ADDENDUM #5 - ADDED BEAM DESIGN OPTION

Texas Department of Transportation
Bridge Division

PRESTRESSED

CONCRETE U-BEAMS

(DESIGN DATA)

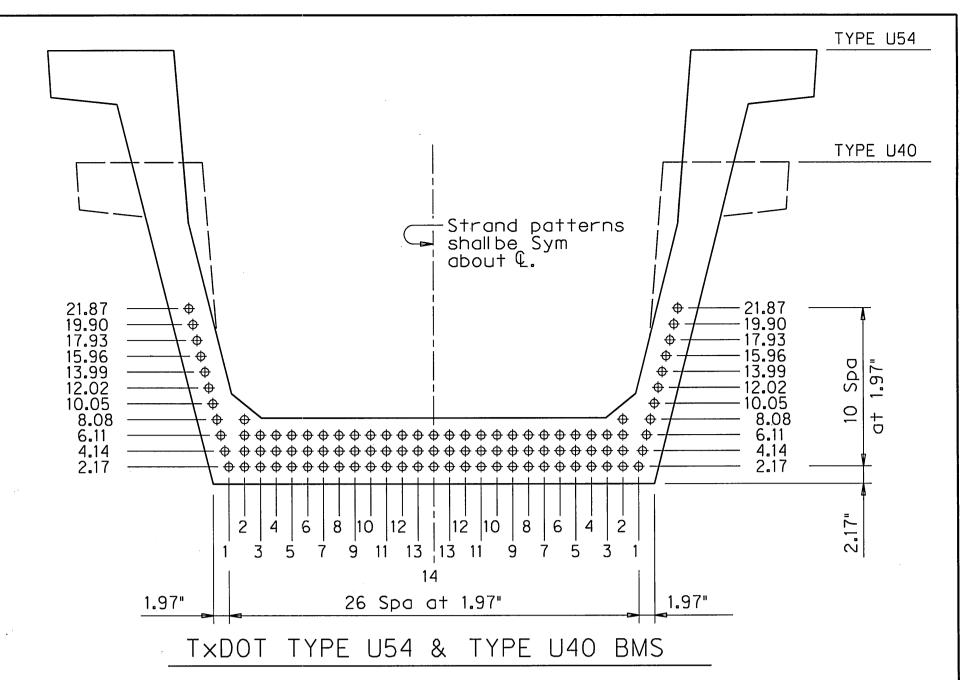
5	PONTE AVE	1	1 & 7	U54		64	.600	270	18.84	18.12	34	2.17	27	20	0	4 8	3 6	2	0	6 00	10° 10° 10° 10° 10° 10° 10° 10° 10° 10°	6.930	8.868	5.381	-4.514	10,279	0.999
	BRIDGE OPTION 1	1	2-6	U54		60	.600	270	19.01	18.40	34	4.14 2.17	27 27	14 20	0	i	3 4	2	0 0	0 0		6.487	7.626	4.888	-4 . 253	10,268	0.392
		\\\\\\\\\\\\\\\\\\\\\\\\\\\\\\\\\\\\\\		<u> </u>		<u> </u>	_	_	<u> </u>		1	4.14	27	14	12	2 ($\int_{-\infty}^{\circ}$		$\overset{\circ}{\sim}$							
																											:
																				·							
									·											,							
ı,																											
ρ η																											
=																											
= ਹੁ																											
ש ה מ																											
		:																									
Ď																								t			
S - I																											
Ď																									14-18-18-18-18-18-18-18-18-18-18-18-18-18-
